Flood Risk Assessment and Drainage Strategy Addendum Report

Project name Land West of Turners Hill Road and North of Huntsland, Crawley Down
Project no. 1620011691-014
Client Wates Developments Ltd
Version 1.0

This Addendum Report is in response to comments from the Lead Local Flood Authority (LLFA) dated to the 26th of February 2025, regarding applications DM/25/0016 and DM/25/0017, and the requested further information.

Figure 2.1: OS Watercourse Network & EA (2025) Surface Water Mapping

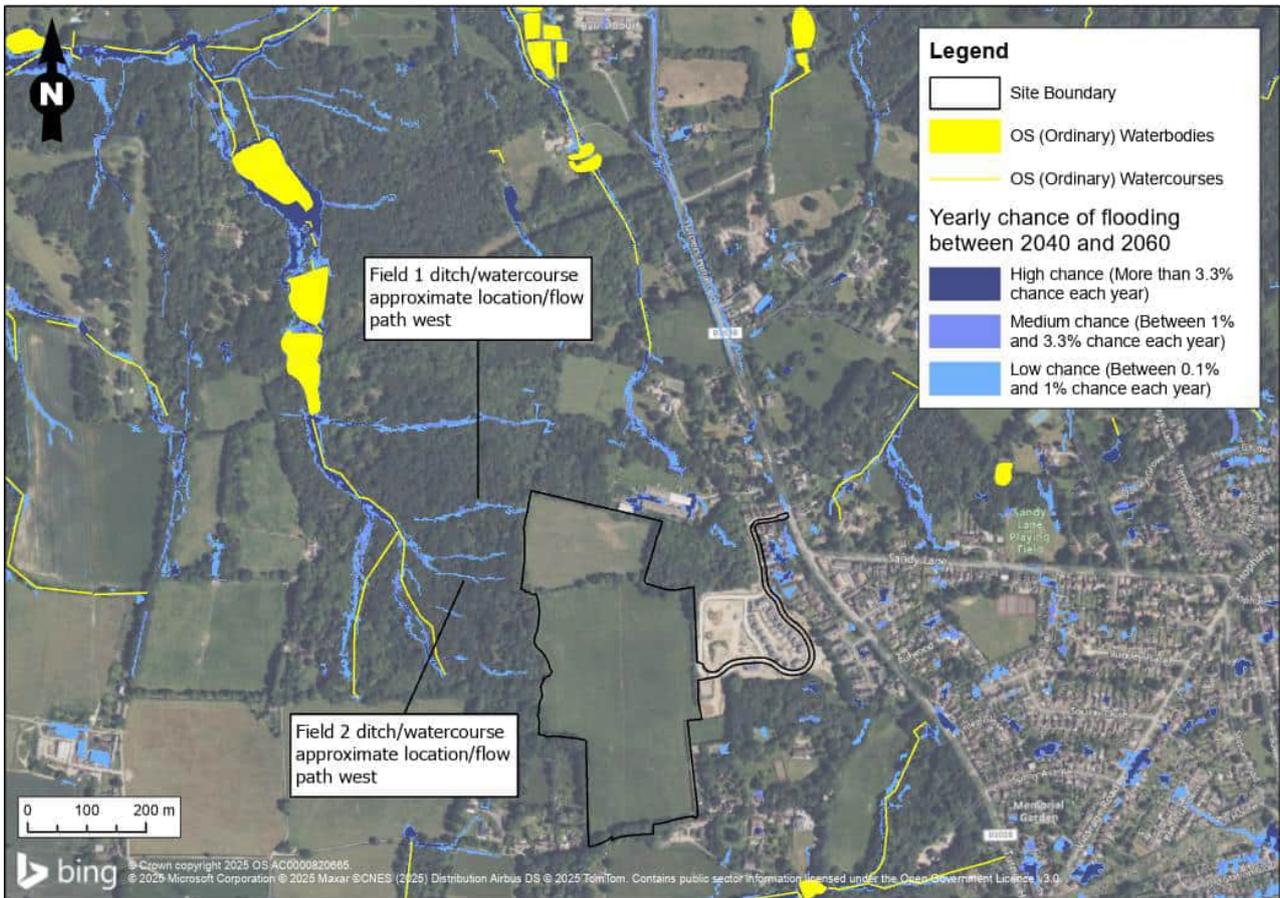
7. *It is unclear how the watercourses connect to the wider watercourse network. In addition the watercourse between Field 1 and 2 has not been picked up on the topographical survey.*

Regarding the wider watercourse network, Figure 2.1 below shows the Ordnance Survey (OS) watercourse network above the updated EA surface water mapping (future scenario) and it confirms the ultimate destination of these identified surface water flow paths to which runoff from the proposed development is intended to discharge. As can be seen within Figure 2.1, runoff from the site ultimately reaches a watercourse within the wooded area flowing approximately south to north.
